Determination 2008/62

Dispute over a building consent for alterations to a house due to the slope of the roof at 6 The Cliffs, Nelson

Figure 1: New roof plan (shaded area shows extent of new roof)

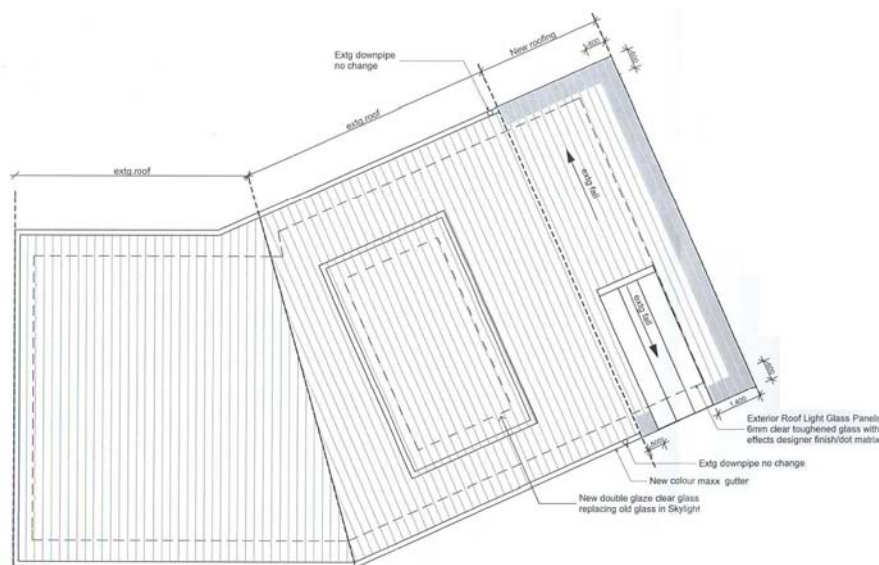
- 3.1 The applicant is in the process of applying for a building consent for the alteration work to the house.
- 3.2 According to the applicant, the territorial authority requires the altered section of the roof to have a 3° pitch in accordance with the Acceptable Solution⁴ E2/AS1 of the Building Code.
- 3.3 The Department received an application for a determination on 19 May 2008.

6.2 In assessing the proposed roof, the authority appears to be of the opinion that, as the pitch of the roof does not comply with E2/AS1 (refer paragraph 5.3) the proposed roof alterations will not comply with the building code.

6.4 I note that the minimum 3° roof pitch for trough section roofing provided for in E2/AS1 is limited to roofs up to 18 metres in length. The length of fall to each side of this roof is approximately 5 metres.

- the area of new roof cladding, that is not a replacement of the existing cladding, is between 5 to 6% of the area of the proposed roof
- the roof alterations proposed for this house are likely to perform at least as well as the existing roof, which has demonstrated its weathertightness performance over 35 years

- half of the area of the new roof cladding is above an open deck
- the new roof cladding does not contain a ridge flashing. The only junctions in the new roof cladding (being those associated with the new skylight) occur over the open deck

- despite the proposed low pitch, maintaining the original roof line will allow junctions to be minimised and simplified, resulting in no significant difference in weathertightness risk from the current situation

- increasing the roof pitch would introduce additional vulnerability to moisture penetration via new complex junctions with the existing roof and walls, and this would increase the weathertightness risk significantly.

6.7 I therefore conclude that the proposed roof pitch will comply with the performance requirements of clause E2 of the Building Code.

6.8 I am therefore of the opinion that, in the circumstances applying to this particular proposal, the authority is incorrect in requiring the roof pitch to comply with E2/AS1.

- 7.1 In accordance with section 188 of the Building Act 2004, I hereby determine that the proposed roof pitch to this building will comply with clause E2 of the Building Code. I accordingly reverse the decision of the authority to refuse to issue the building consent, in respect of the proposed roof pitch only.
